# Technical Service Information

## FORD A4LD SENSITIVE 4-3 DOWNSHIFT

Figure 1

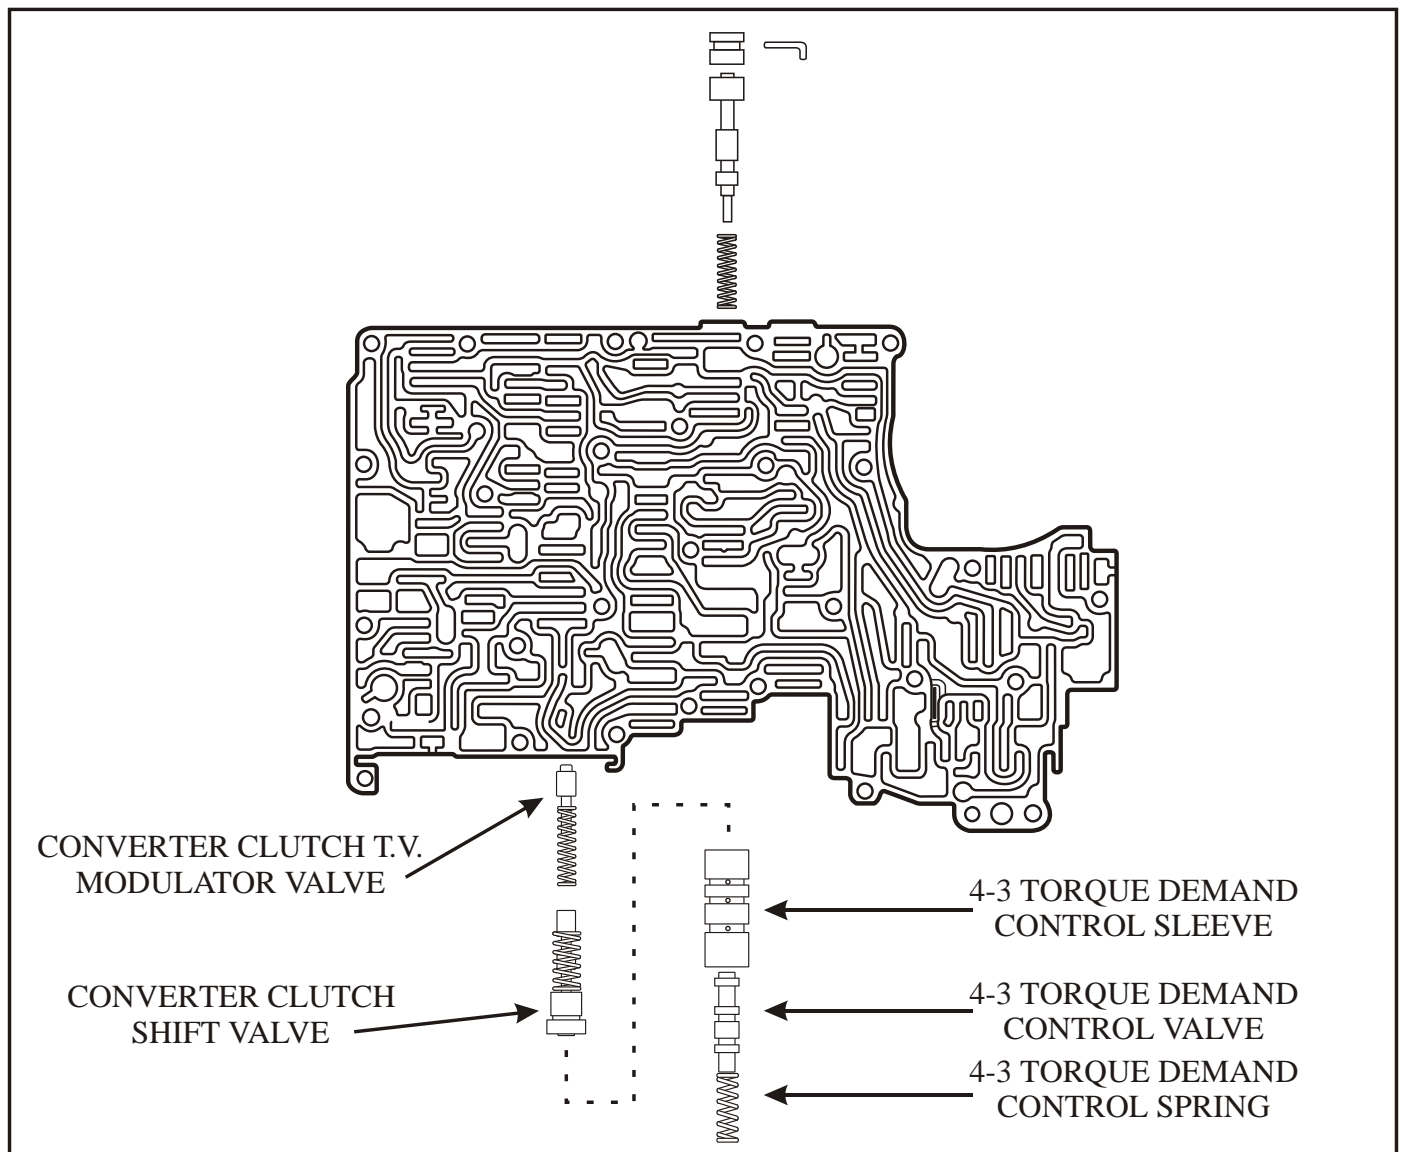
**COMPLAINT:** Vehicles equipped with the A4LD transmission may exhibit a sensitive 4-3 downshift.

**CAUSE:** The cause may be a weak or broken throttle pressure boost spring and/or 4-3 torque demand control spring in the valve body.

**CAUSE:** Remove the valve body and refer to figure 2 for bore identification. Discard the 4-3 torque demand control spring and the throttle pressure boost spring as shown in figure 1. Replace the 4-3 torque demand control spring (BORE 202) with the dark green spring, replace the throttle pressure boost spring with the light green spring (BORE 212) both available in OEM service kit E5TZ-7E479-A
